# Access Compliance Report

## Public Rights-of-Way

Intersection ID: 13752	Main Street: RENNELAER_AV	Cross Street: SOUTH_BV	Location:	N
ADA ID: 2E65F810F5B7	Ramp Type: Perp	Initial Pass/Fail: Pass	Overall Compliance: No	Severity Score: 0
Codes/Mitigation Info/Possible Solution		Field Measurements/Component Compliance

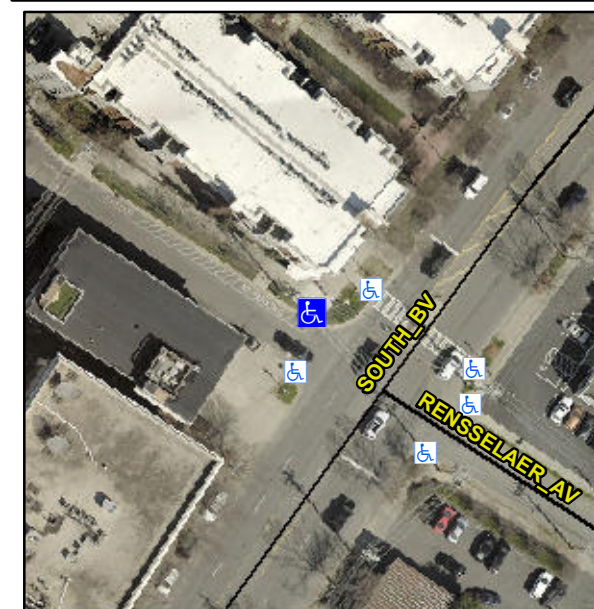
**Not Found, R304.2.2-Perp, R304.3.2-  
Para, R305.2, R304.5.3**

Compliance	Description	Data	Compliance	Description	Data
N/A	Ramp Length (in)	93.0	Yes	Ramp Slope (%)	7.9
Yes	Ramp Width (in)	48.0	Yes	Ramp XSlope (%)	0.1
N/A	Flare Type LT	Sloped	N/A	Flare Type RT	Sloped
N/A	Flare Slope LT (%)	34.2	N/A	Flare Slope RT (%)	29.8
N/A	Flare Traversable LT?	No	N/A	Flare Traversable RT?	No
Yes	Landing Length (in)	96.0	Yes	DWS Provided?	Yes
Yes	Landing Width (in)	96.0	Yes	DWS Contrast?	Yes
No	Landing Slope (%)	4.3	Yes	DWS Length (in)	24.0
Yes	Landing X Slope (%)	1.2	Yes	DWS Full Width?	Yes
N/A	Landing Curb? (Y/N)	No	No	DWS Offset (in)	6.0
N/A	Shared Landing?	No			
Yes	Gutter Ponding?	No	Yes	Gutter Slope (%)	0.5
Yes	Gutter Lip Ht (in)	0.0	No	Gutter X Slope (%)	3.2
N/A	Painted X Walk1?	No	N/A	Painted X Walk2?	N/A
	X Walk 1 Direction	To SW		X Walk 2 Direction	N/A
N/A	X Walk 1 Width (in)	N/A	N/A	X Walk 2 Width (in)	N/A
	X Walk 1 Slope (%)	5.9		X Walk 2 Slope (%)	N/A
	X Walk 1 X Slope (%)	1.6		X Walk 2 X Slope (%)	N/A

**Remove & Replace Entire Ramp.  
Remove & Replace Gutter.**
